SOPWITH PUP

TECH NOTICE

Please refer to this Tech Notice when joining the stab and fin to the fuselage on page 5.

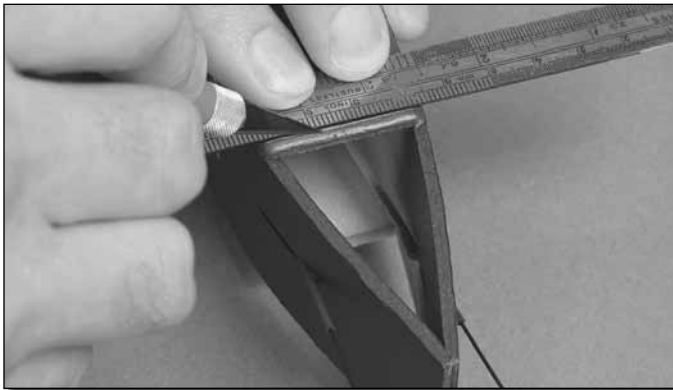
When test-fitting the stab/fin assembly to the fuselage as shown in step 2, check to see if there is a gap between the rudder and the fuselage. If a gap does not exist, proceed with assembly as instructed in the manual. If there is a gap, trim the top of the fuselage as described below.

Use a straightedge and a sharp hobby knife to trim end of the fuselage top as necessary to close the gap—typically removing 1/16" to 3/32" [1.6–2.4mm] is suitable. This will bring the stab/fin assembly forward, eliminating the gap.
